Service Letter No. 422

SUBJECT: Rework of Propeller Spinner Assembly

MODELS AFFECTED: PA-30 Twin Comanches, Serial Nos. 30-1 to 30-348 inclusive

SKETCH A
KIT 756 796
Spinner Attachment

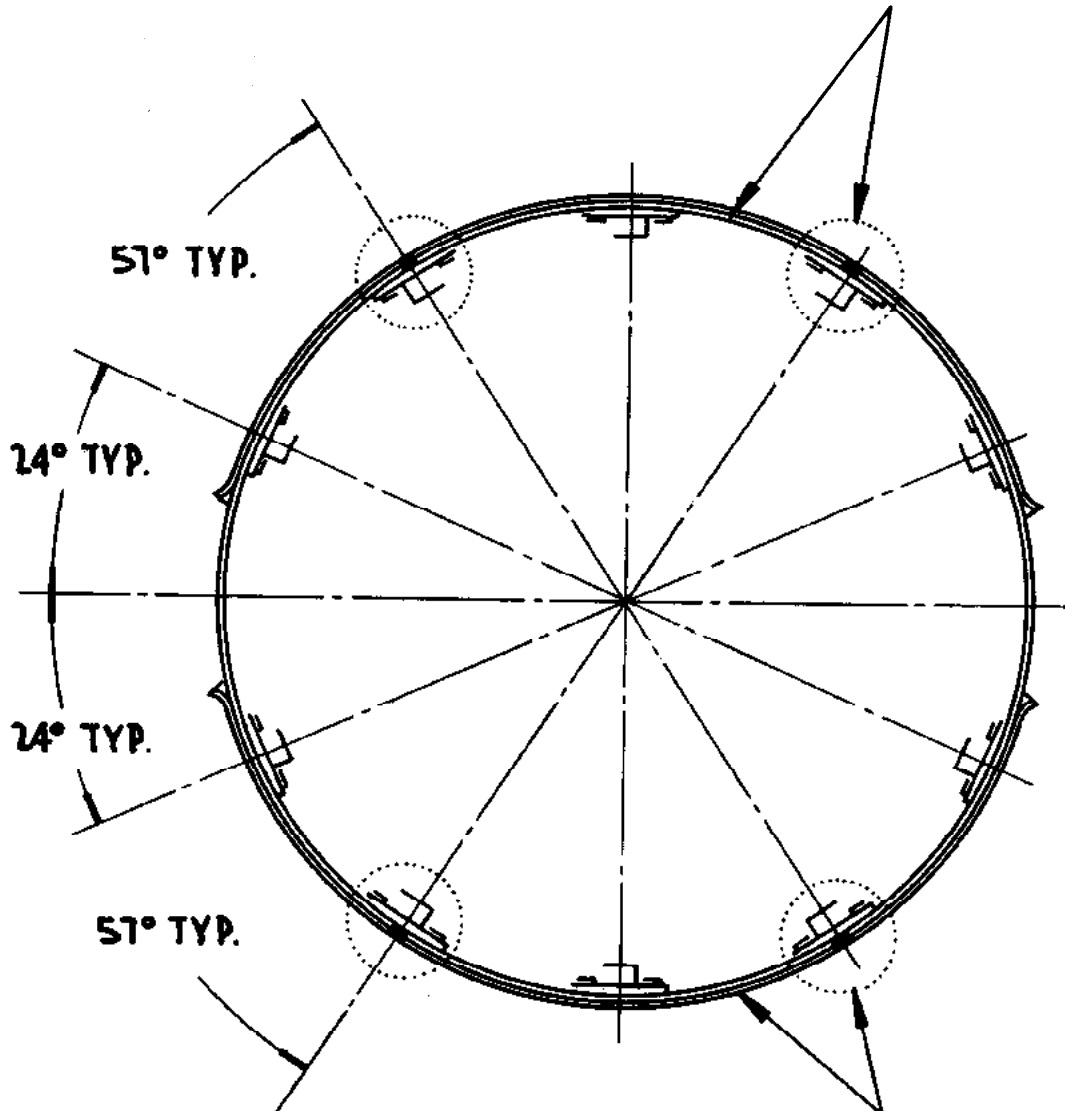
We have had reports which indicate that the propeller spinner attaching screws on the subject aircraft are chafing the spinner. In some cases the screw head had chafed sufficiently to wear through the spinner.

In order to correct this situation we have added four (4) additional screws to each spinner. These screws are installed midway between existing screws. Refer to sketch on the reverse side of this service letter.

.189/.191 HOLE (4 REQ.)
ANCHOR NUT NAS686A3 (4 REQ.)
RIVET AN426AD3-4 (8 REQ.)
(ADD TO 23815 BULKHEAD ASSY.)

.189/.191 HOLE (4 REQ.)
(ADD TO 23818 SPINNER ASSY.)

SCR. AN526-1032128 (4 REQ.)
(AT INST.)
